Application for Waiver from Construction Standards for Public Water Systems

Water System Name: Falls City

Project or Facility: Waterline Improvements

☒ Plan Review # 43-2025

☒ Attachments (describe): See this page and the next page.

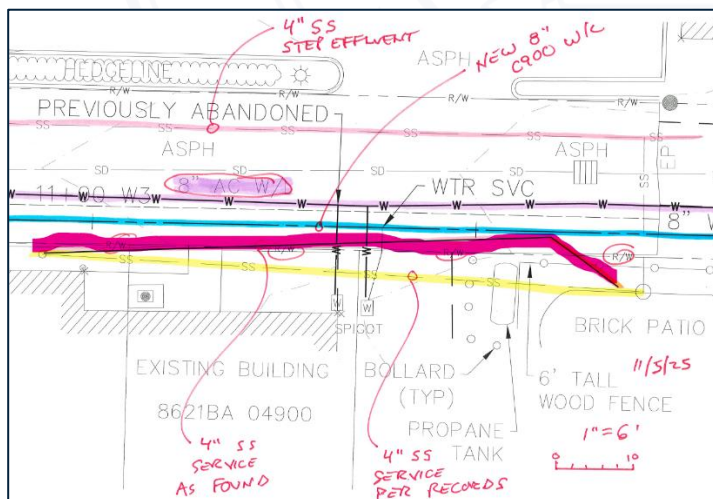
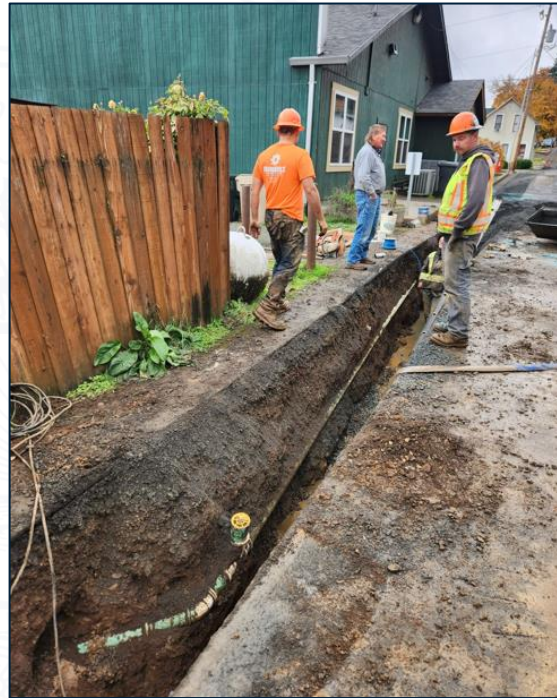
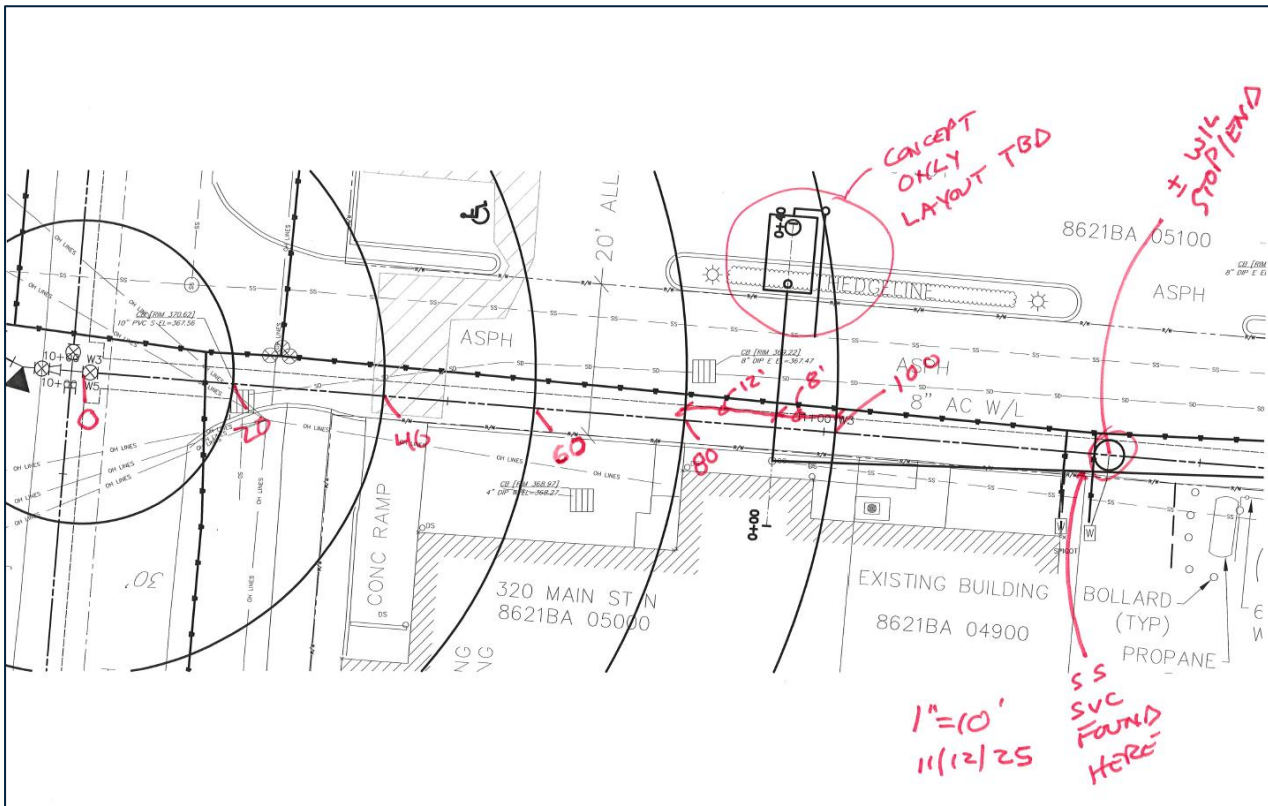
Describe situation that conflicts with the standard. A new waterline was being constructed when an existing sewer service was discovered in the waterline trench running parallel to the waterline. The City has decided to abandon the parallel sewer service and reroute it by crossing over it to the north to a new septic tank and then from the tank back to the sewer main which is $\pm 12'$ north of the waterline. Due to the depth of sewer main the crossing sewer service must be above the new waterline.

Describe why meeting the standard is highly burdensome or impractical. This waiver is being requested because the variation from the standard is minor and is not considered to result in a decrease in the protection provided to the public waterline. The waterline was being installed starting at 3rd Street and the sewer service pipe running parallel to the waterline was not discovered until approximately 140 ft of water pipe had been installed. In the natural course of installing the pipe with 20 ft lay lengths, the stick of pipe at the location where the new sewer service is to be installed will not be perfectly centered on the crossing. Instead of 10 ft of pipe on each side of the crossing, there will be 12 ft on the west side and 8 ft on the east side. The sewer service crossing will have new pipe and the sewer service pipe bedding will be compacted before the new sewer service pipe is installed.

Describe proposed alternate measure that provide adequate protection to public health and safety. As discussed above, the alternate measure is to have the center of the 20 ft length of pipe offset 2 ft to the west of the pipe. With 8 ft of distance from the sewer service crossing to the nearest water main pipe joint, the basic intent of the standard is believed to be met. To verify that the waterline joints on each side of the crossing are properly sealed they will be visually inspected during the waterline pressure test.

Entered into waiver database ☒☒ Plan Review Coordinator's notes: Mitigation appears to provide equivalent alternate measure.

☒ Approved Comments:☐ Denied
